DEVELOPMENT REVIEW BOARD
SUPPLEMENTAL SUBMITTAL

PROJECT NO. 2018-001579
Application No. SI-2020-01477

This letter outlines the modifications that have been made to the Apartments at Pennsylvania St and Indian School Rd application for a major site plan amendment to the approved Winrock Town Center Site Development Plan (PR-2018-001579) to address the agency comments that were received.

Lofts @ Winrock Town Center

SHEET NO. **SDP1.1**
OF

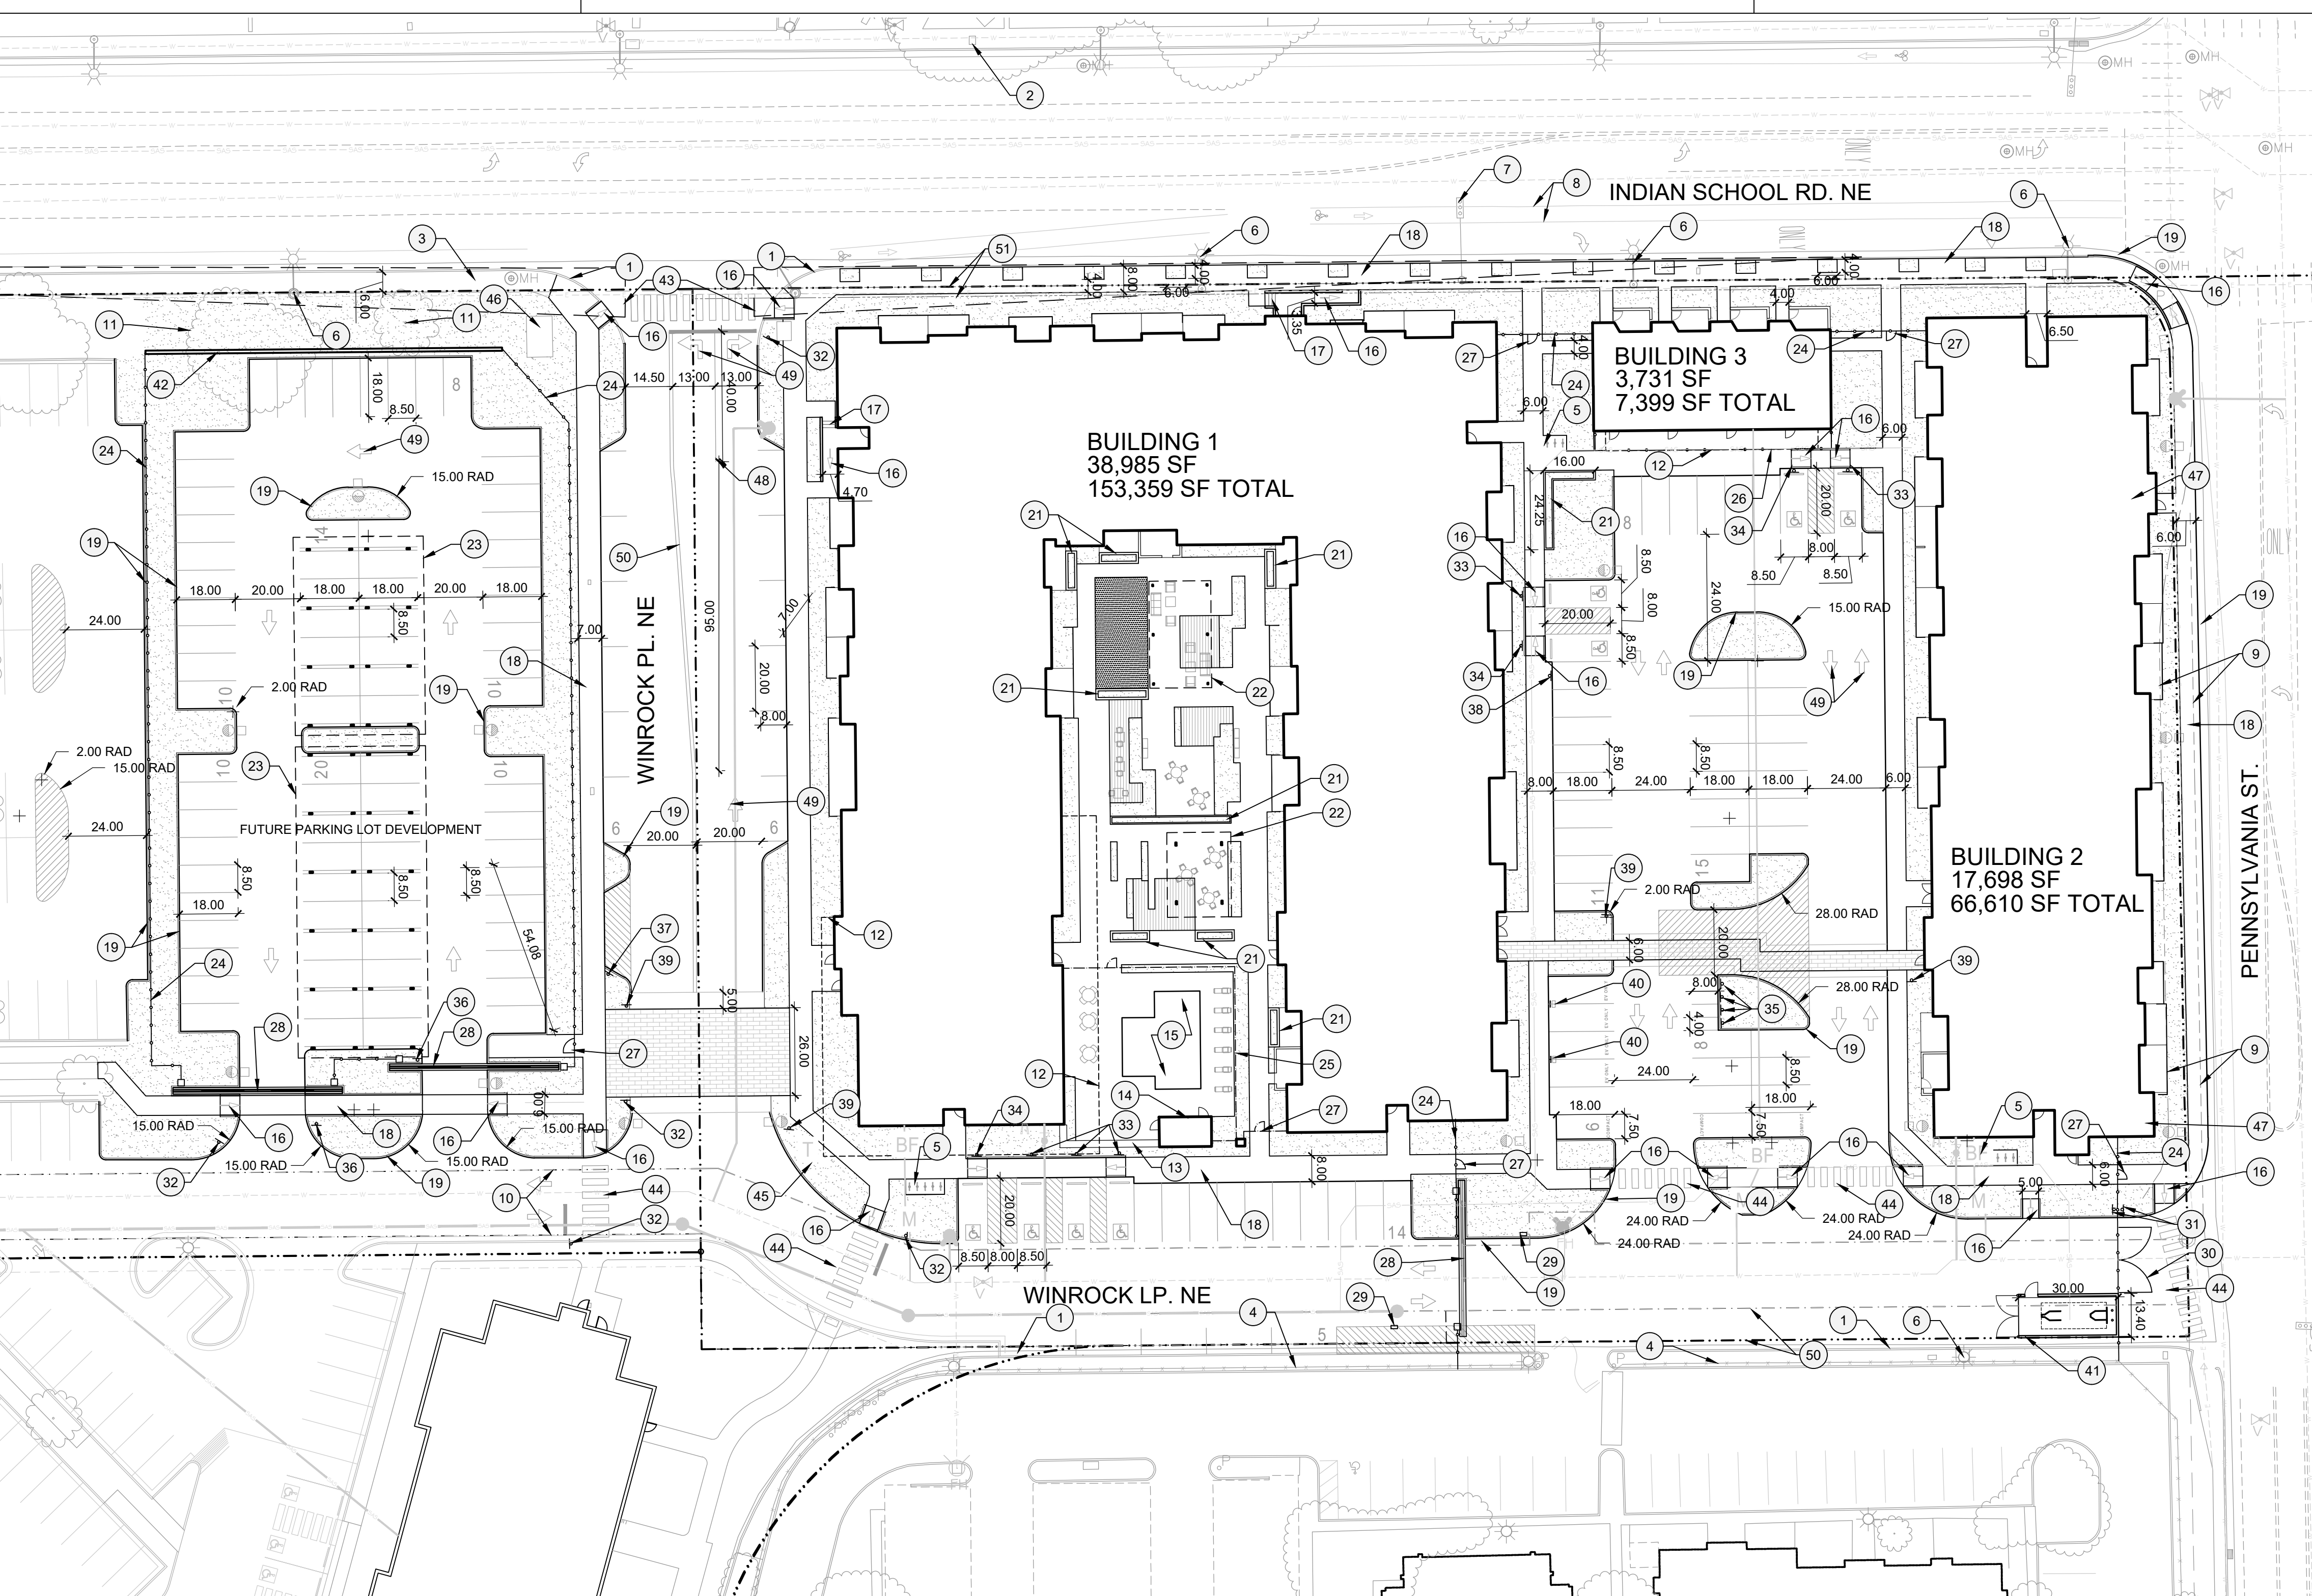
2. Bolden the note stating that the public improvements shall be built per the work order drawings.

3. For a road exiting onto Indian School Road, use a yellow double stripe for separating opposing directions of traffic and use a single white stripe for separating traffic lanes that are traveling in the same direction. Pavement arrows are white as well.

4. Include "Yield to Pedestrians" signage for the wide crosswalk.

- i. Please provide documentation that the ABCWUA will have ability to access the gates (key note 28 and 30) for maintenance.

General Sheet Note has been made bolder.

A Yellow double stripe from Indian School to raised crosswalk has been added. Pavement arrows are white.

Site signage is added to raised crosswalk and is labeled by a keyed note 39.

Access will be provided to the Fire Department, ABCWUA, and Solid Waste via job access/keyed entry. Gate at Pennsylvania (keyed note 30 on SDP 1.1) is an emergency exit only gate. Language has been added to site plan and utility plan.
